HHH1 HILL HOUSE HAMPSTEAD 87 REDINGTON ROAD NW3

3. COMPARISON BETWEEN EXTANT PERMISSION FOR ANNEXE BUILDING 2014/7140/P
& PROPOSED SCHEME 2020

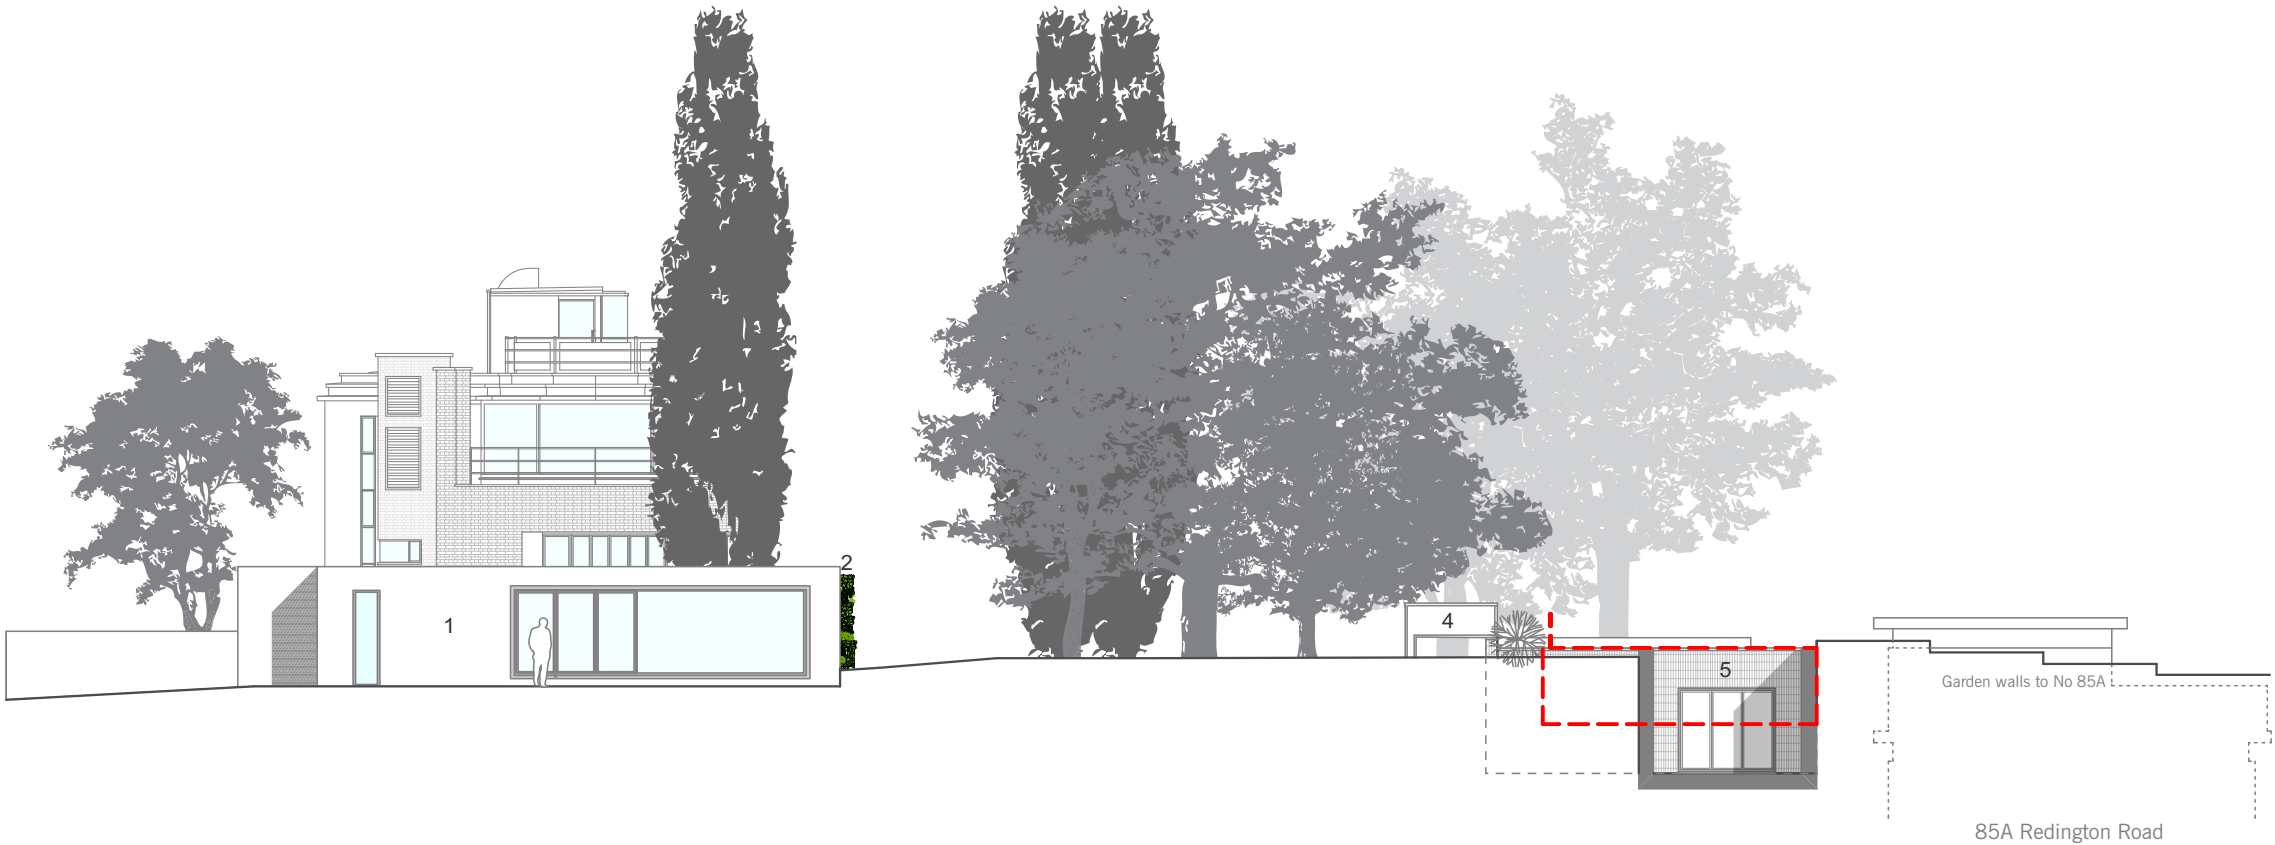
Rev E - 211020
Annexe arcade revised.

Rev D - 081014
Outline of proposed extension revised.

Rev C - 161109
Materials to entrance of car park indicated.

Rev B - 091009
Dining room reduced north by 500 mm.

Rev A
Non-accessible low level planter added to south of annex.

1.2m glazed screens added to prevent access and overlooking.

1/3 of library window specified obscured glass and non-openable.

Planters and guarding added to roof of annex at rear.

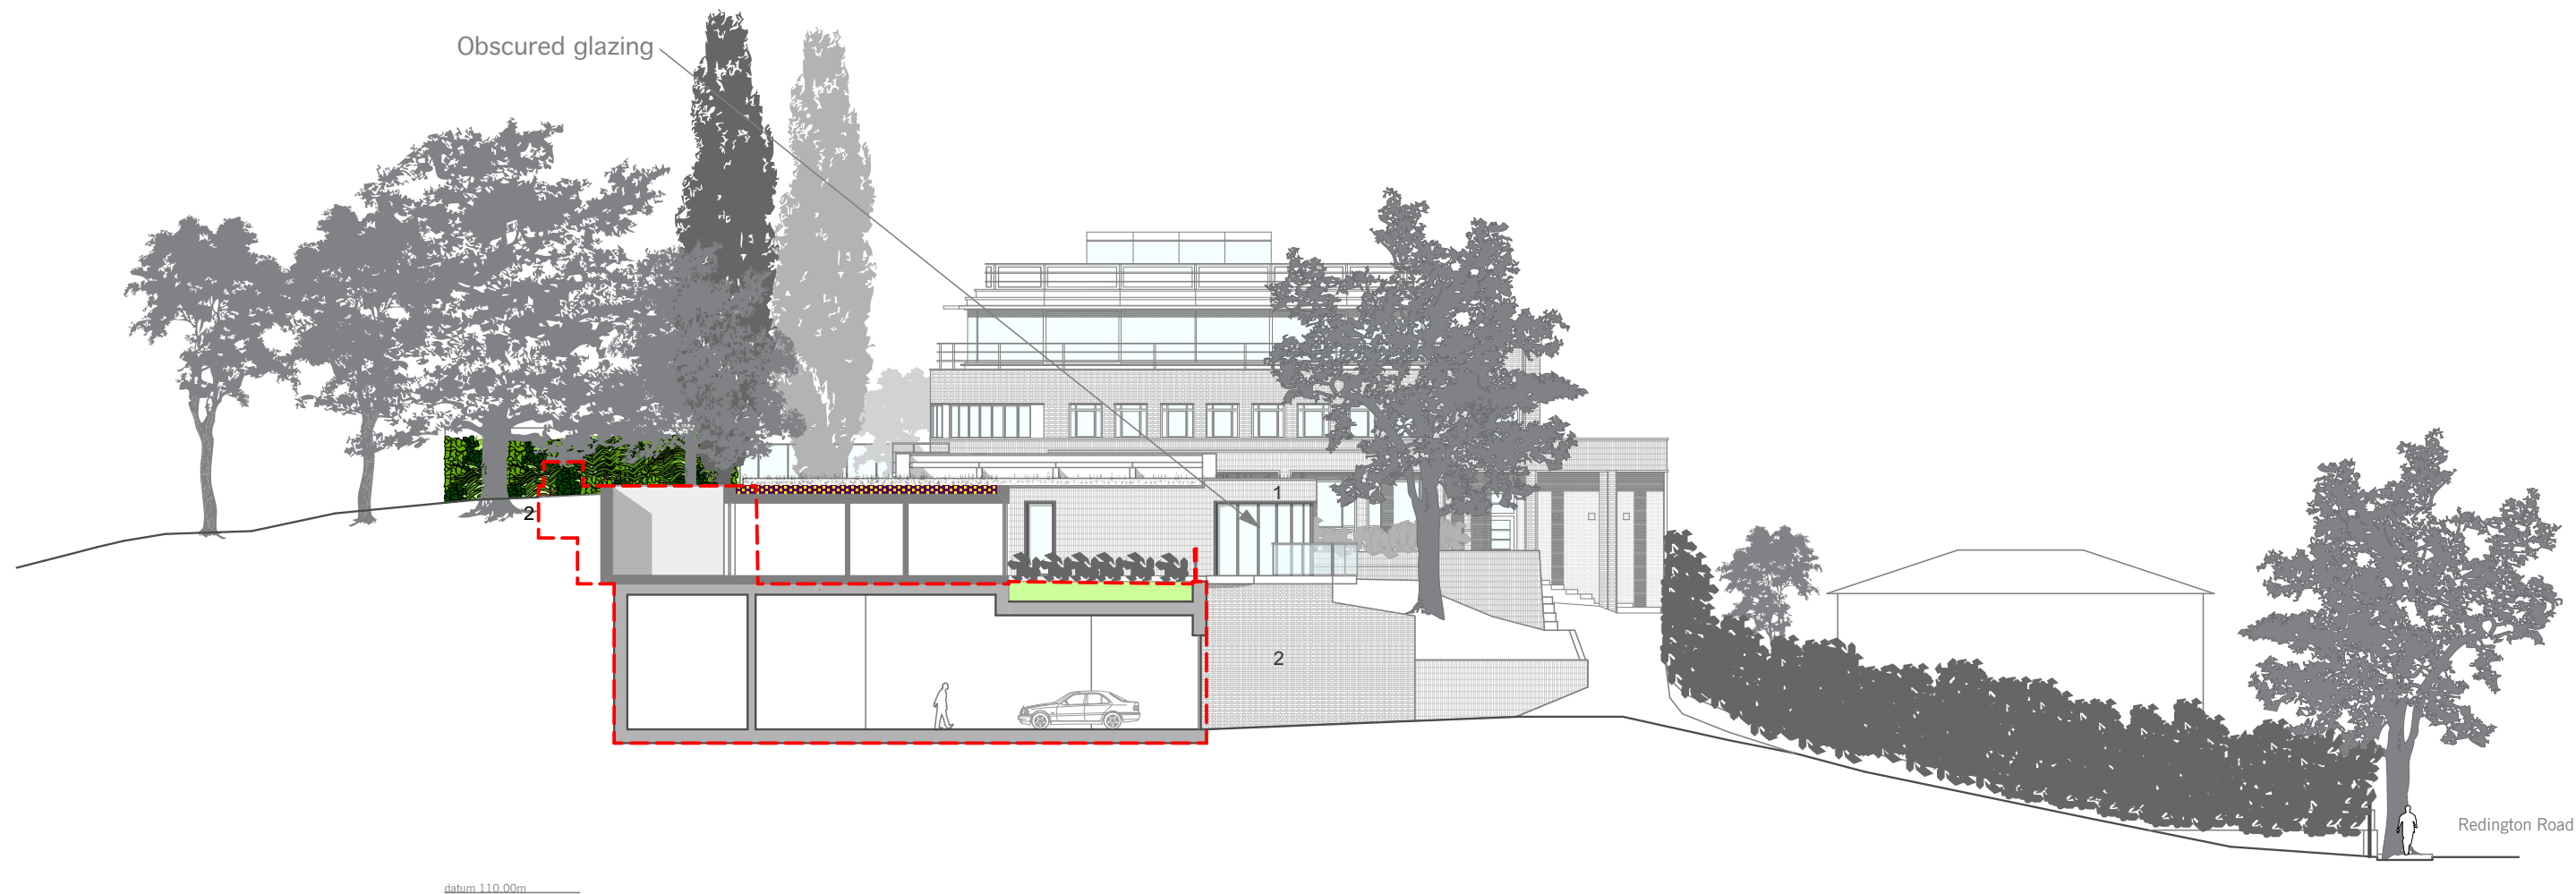
- Cut back north-west corner of annexe
- Annex arcade revised.

Outline of proposed extension revised.

Dining room reduced north by 500mm.

Kitchen moved north.

Site fence of north boundary to 89 Redington Road indicated.

Planters and guarding added to roof of annex to make it non-accessible.

Picture window added to west elevation of rear extension.

Context of 85A added to drawing.

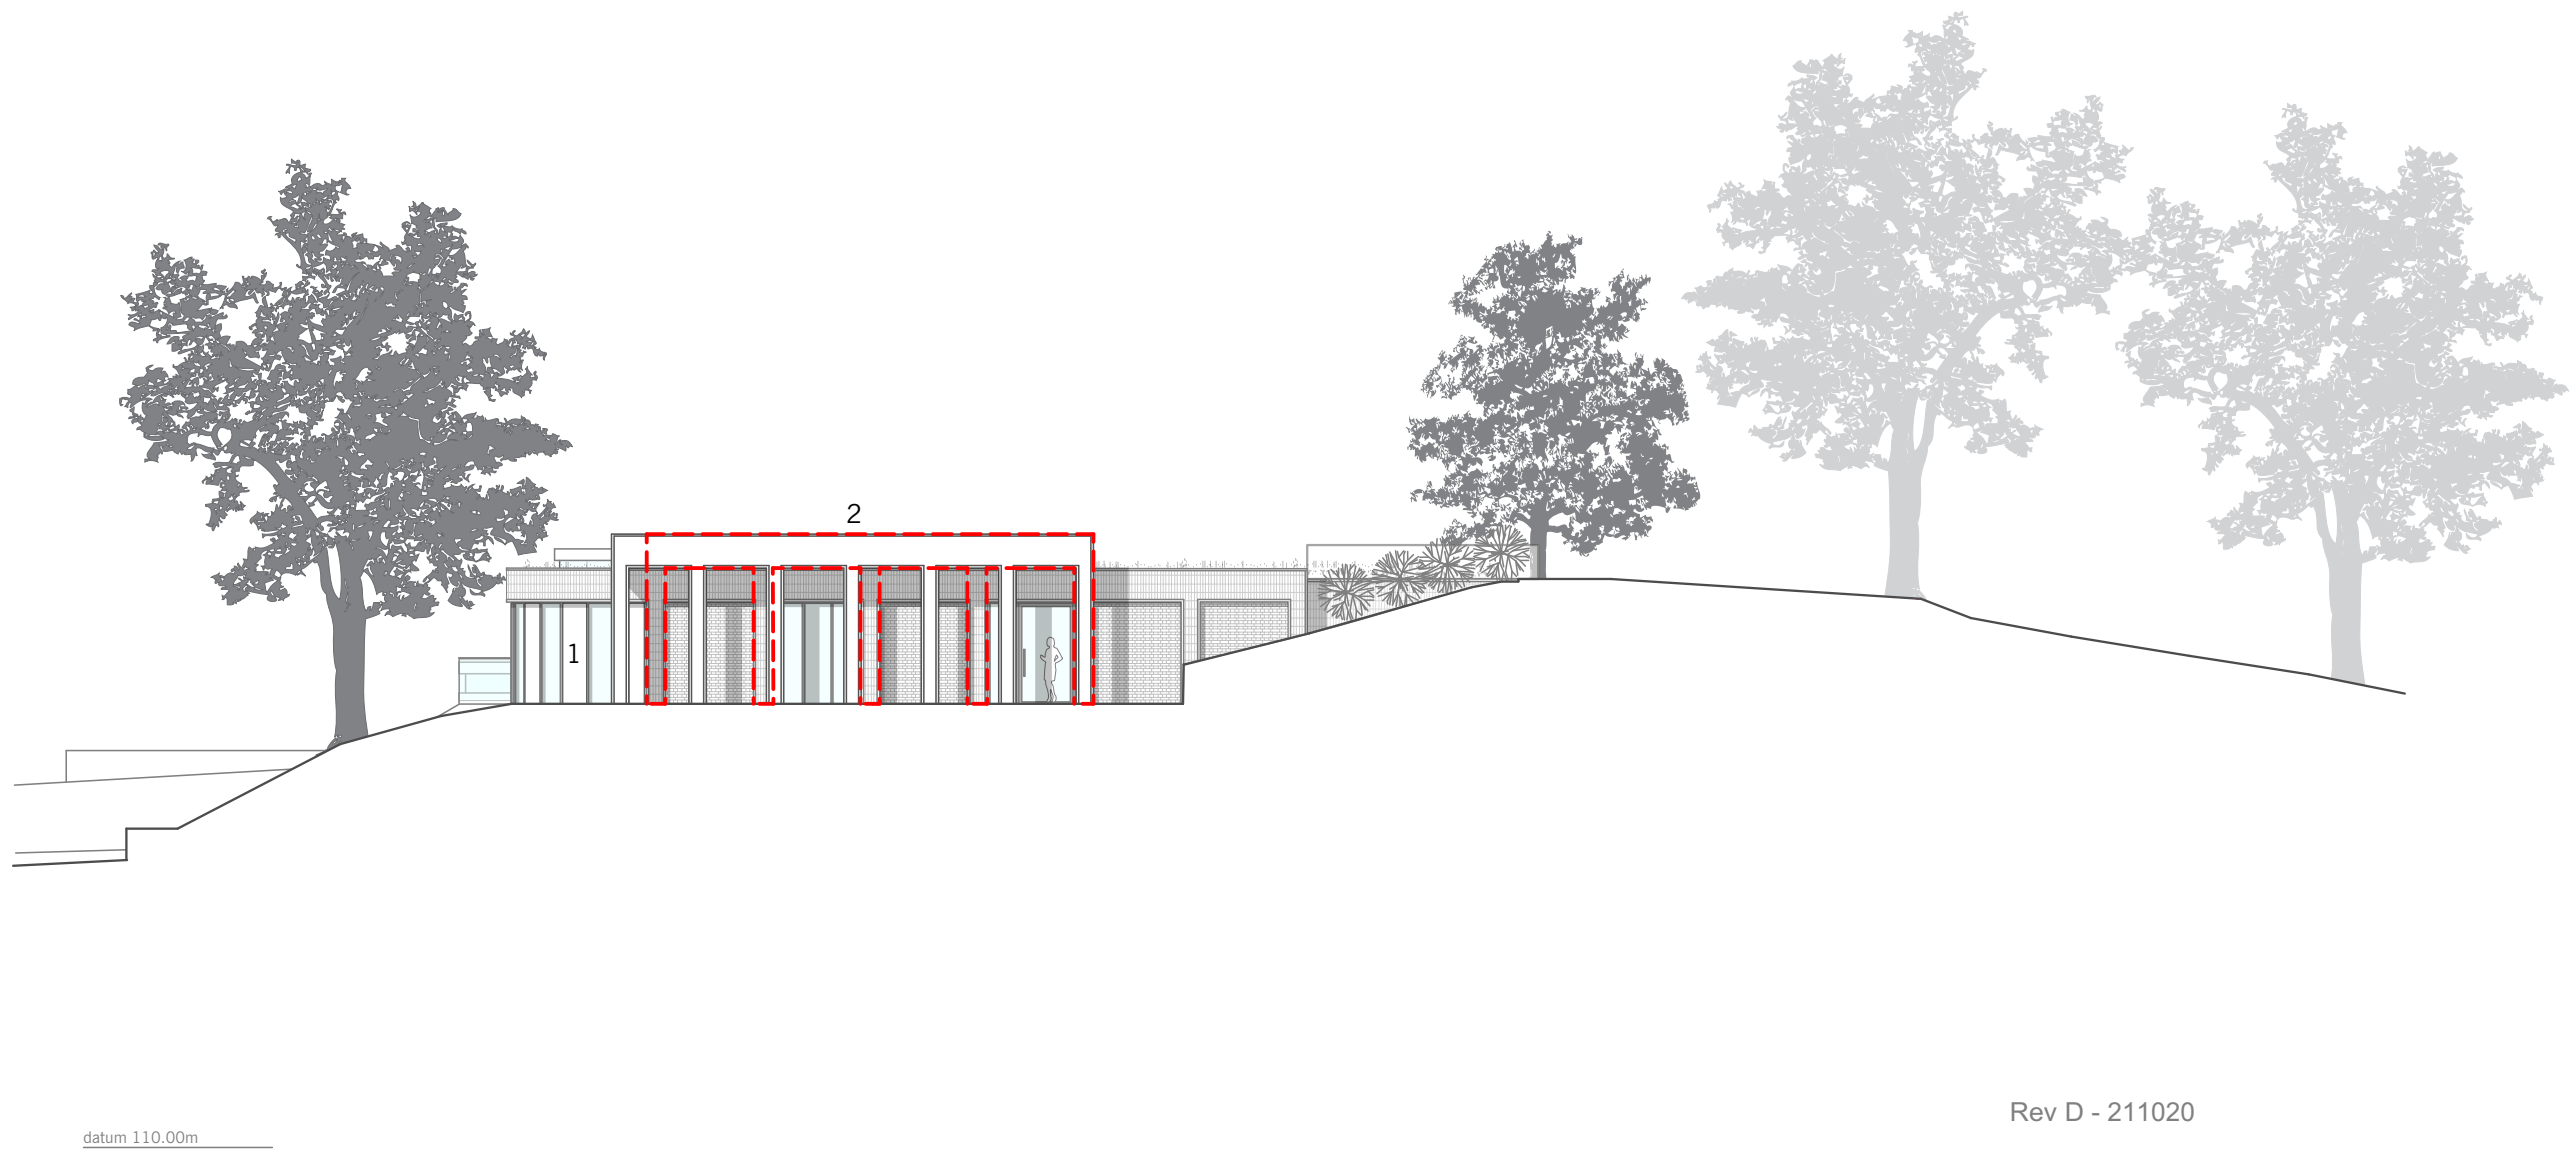
Basement level lowered.
- Rev A

Non-accessible low level planter added to south of annex.
- Rev D - 211020

Cut back north-west corner of annexe
Metal grating decking with planted trees over parking for one car.
- Rev C - 081014

Outline of proposed extension revised.
- 1.2m glazed screens added to prevent access and overlooking.
- 1/3 of library window specified obscured glass and non-openable.
- Planters and guarding added to roof of annex at rear.

Column spacing and cladding for arcade revised.

Outline of proposed extension revised.

South extension cut back to protect root ball of oak T11.

Planters and guarding added to roof of annex to make it non-accessible.
